SERVICE BULLETIN

SB043-598

Subject: Nose Struts (All Models)

Status: Mandatory Inspection and Replacement (if necessary)

**LIV/LES Nose Strut Cross Section
(L235-L360 is similar)**

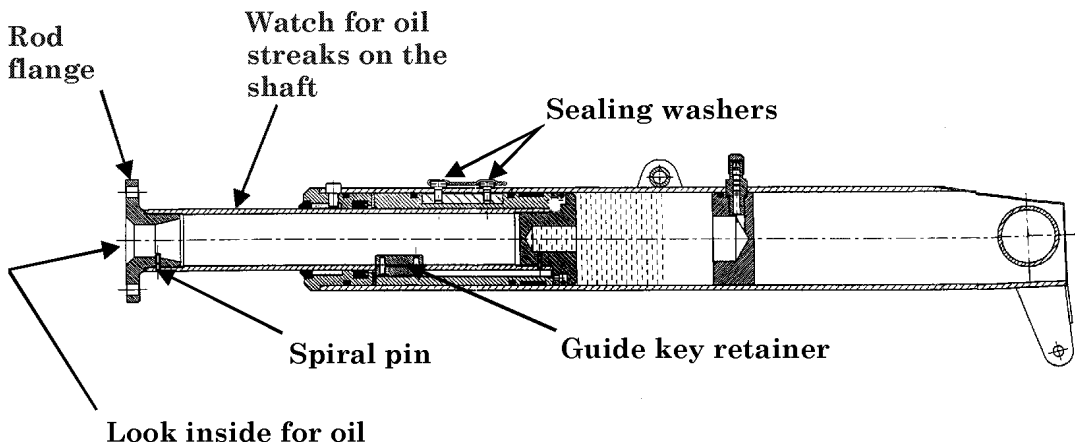
It is important to address the nose gear shimmy at the first sign. A shimmy is usually the result of a low oil level in the nose strut. The most common location of an oil leak is through the guide key retainer. This will result in the oil draining to the inside of the nose strut. It is not visible because the fork seals the inside of the strut. We suggest that if you suspect a leak, remove the fork and look inside the strut. If there is a leak, oil should be pooled up on the top of the fork. Also, if you see any oil streaks draining down the sides of your shaft, you may have another kind of internal leak. If you have a leak please contact our parts department for an RMA number prior to sending the strut to us for servicing.

Another potential location for leaks is through the sealing washers at the front of the strut. This leak is visible on the outside (see figure). In the case of a leak past the sealing washer order new washers through us (P/N Z17B014). Remove the bolts, install the washers, torque bolts to 35 inch-lbs. Use dry Nitrogen to recharge the strut; 170 lbs. for the 320/360, and 250 -300 lbs. for the IV and ES. **IMPORTANT!** Do not use compressed air which contains water or moisture. This will cause accelerated corrosion within the nose gear strut.

Note: If you have experienced nose gear shimmying, there is a possibility that the spiral pin (ref. Figure above) may have sheared. Lift the aircraft nose off the ground and wiggle the wheel while looking for looseness of the pin. Also make sure the rod flange is not rotating (it should remain fixed with the shaft.)
